Clinton Power Station

Clinton Power Station
Facility Operating License No. NPF-62
NRC Docket No. 50-461

Subject: Response to Request For Additional Information

Attachment A
Response to Request For Additional Information
Clinton Power Station, Unit 1
1 of 21

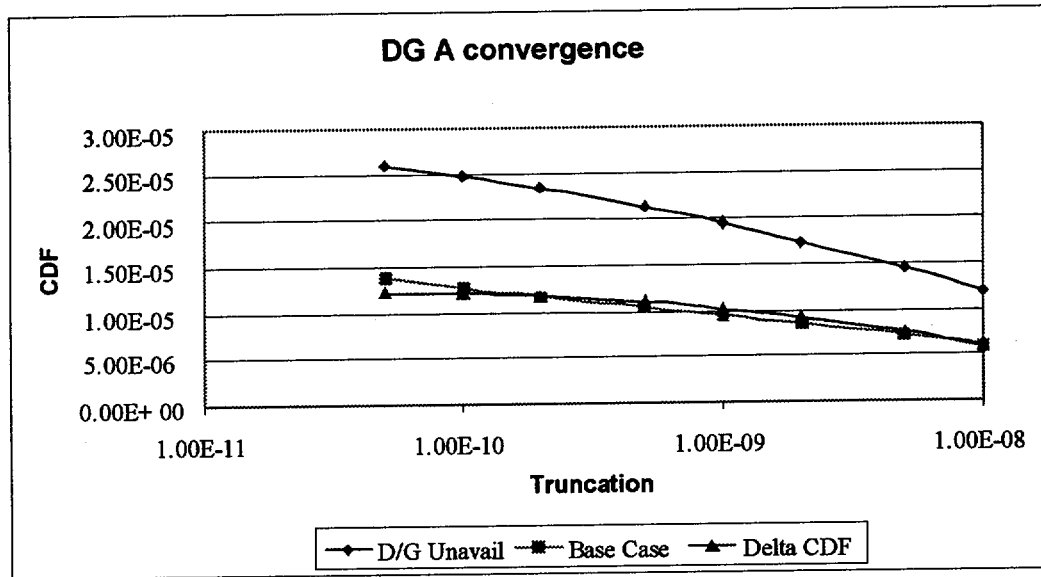
Convergence (F&Os QU-24)

The Peer Review/Certification Team identified the fact that at the lowest truncation limits used for the SETS computer code (i.e., sequence quantification), the CDF does not yet appear to converge. For the long term, convergence studies will be undertaken using different methods or computer codes. For the EDG AOT risk study, we have performed convergence studies with the current model. As shown by

the graph below, the CDF difference between the base case and the case with a diesel unavailable (i.e., the parameter of interest for the AOT extension risk study), has plateaued at the truncation limit used.
